AMENDMENTS TO THE DRAWINGS:

REMARKS/ARGUMENT

Fig. 12a

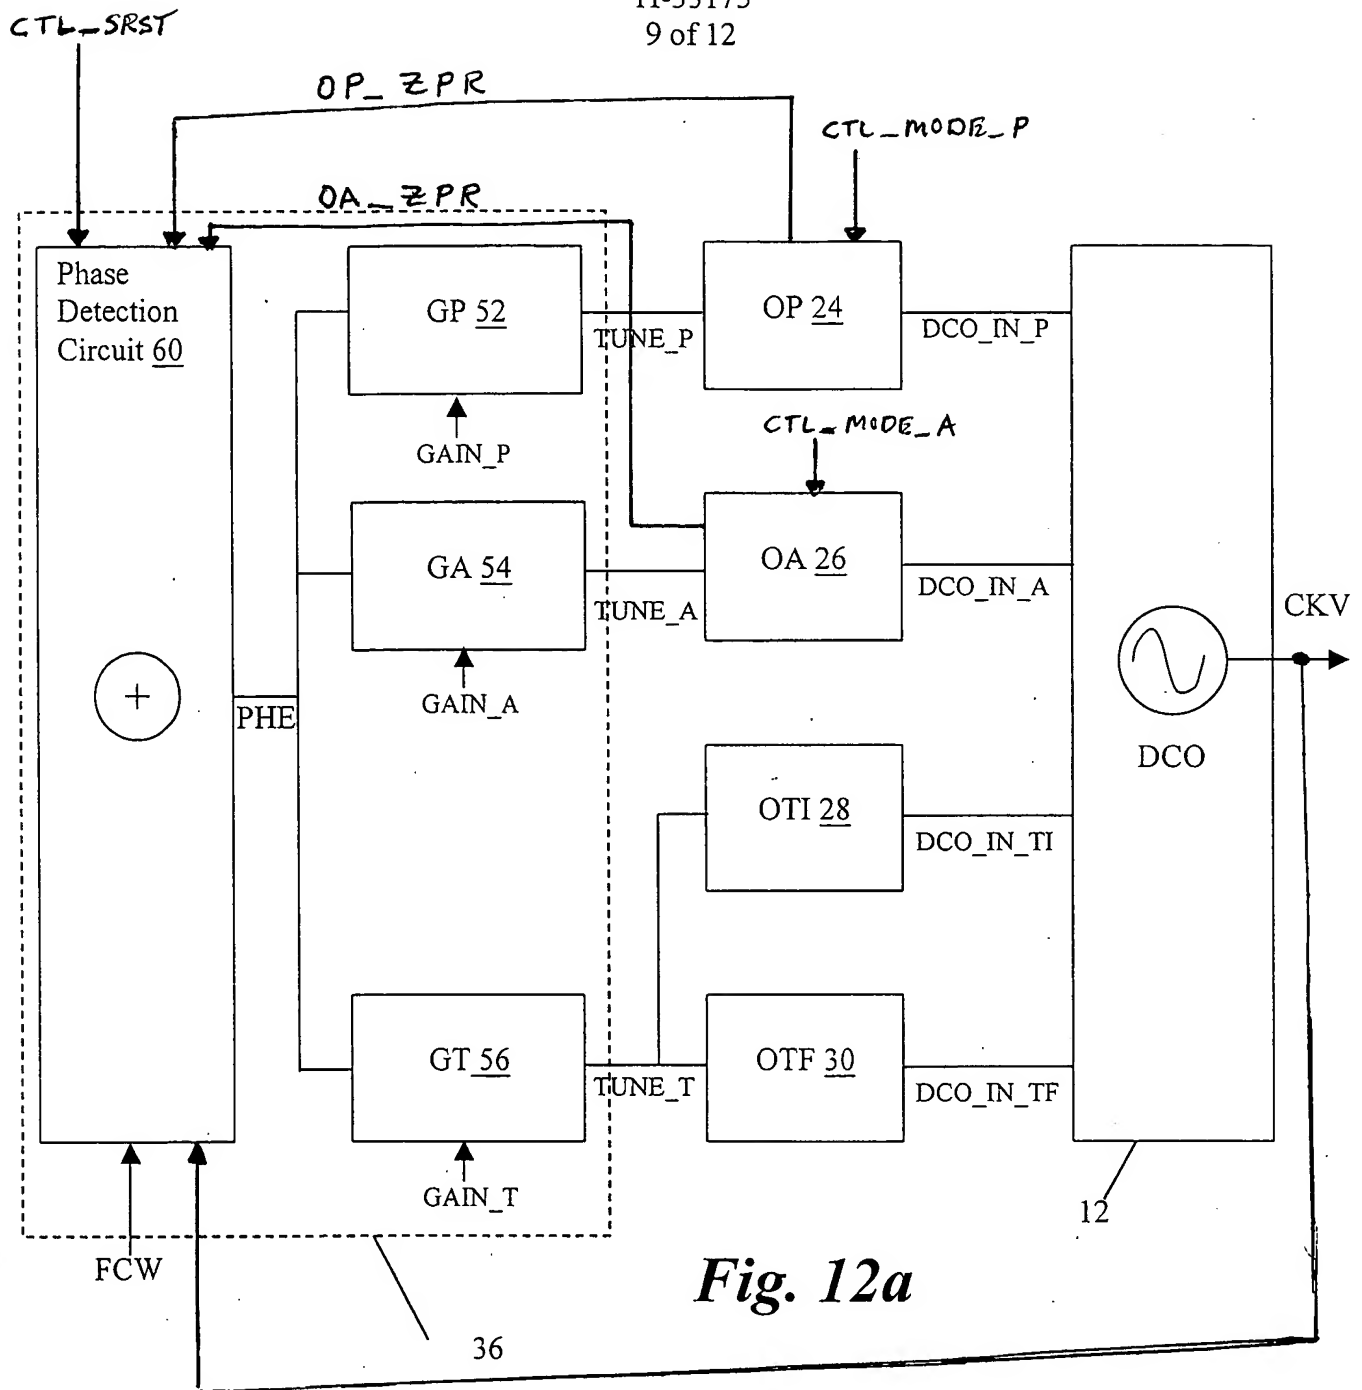
Applicants propose amending Figure 12a to clarify the invention. Applicants propose:

1) adding a signal line from the output of DCO 12, which outputs clock signal CKV, to an input of Phase Detection Circuit 60. Support for this amendment is found in paragraph [0033] and Figure 1 & 12b.

2) adding a signal line, coupled to receive a signal CTL_SRST, to an input of Phase Detection Circuit 60. Support for this amendment is found in paragraph [0056] and Figures 13 & 14 which show synchronous reset CTL_SRST.

3) adding a signal line, enabled to carry a mode switch signal OA_ZPR, from an output of control circuit 26 to an input of Phase Detection Circuit 60. Support for this amendment is found in paragraphs [0066-0067] and Figures 13 and 14.

4) adding a signal line, enabled to carry a signal OP_ZPR, from an output of control circuit 24 to an input of Phase Detection Circuit 60. Support for this amendment is found in paragraphs [0065 & 0067] and Figures 13 and 14.

5) adding a signal line, coupled to receive a signal CTL_MODE_P, to an input of control circuit 24. Support for this amendment is found in paragraphs [0064-0065] and Figure 13.

6) adding a signal line, coupled to receive a signal CTL_MODE_A, to an input of control circuit 26. Support for this amendment is derived from Figure 13 which shows CTL_MODE_P for the PVT oscillator controller or interface 24. This equivalency is established in [0066]. The acquisition controller 26, as described in [0068], is significantly identical to the controller 24, and has an equivalent mode switch signal. Accordingly, Figure 12a has been amended to show the CTL_MODE_P and CTL_MODE_A signals entering OP 24 and OP 26 circuits, respectively.

Figure 12a has been amended to add mode switch signals OP_ZPR and OA_ZPR which enter the phase detection circuit 60 from the OP 24 and OA 26 circuits, respectively, to better illustrate the invention.

Applicants further propose amending Figure 12a to clarify the invention. Figure 12a shows more details and more actual interconnects between the digitally-controlled oscillator 12, plurality of control circuits 24-30, and the phase detection circuit 60 than does Figure 1. While a “mode switch signal” is not shown in Figures 1 or 12a, it is shown in Figure 13 as CTL_MODE_P for the PVT oscillator controller or interface 24. This equivalency is established in [0066]. The acquisition controller 26, as described in [0068], is significantly identical to the controller 24, and has an equivalent mode switch signal. Figure 12a has been amended to show the CTL_MODE_P and CTL_MODE_A signals entering OP 24 and OP 26 circuits, respectively. No new matter has been added. Applicants respectfully request approval.

All proposed amendments to Claim 12a are illustrated in red ink. No new matter has been added. Applicants respectfully request approval.
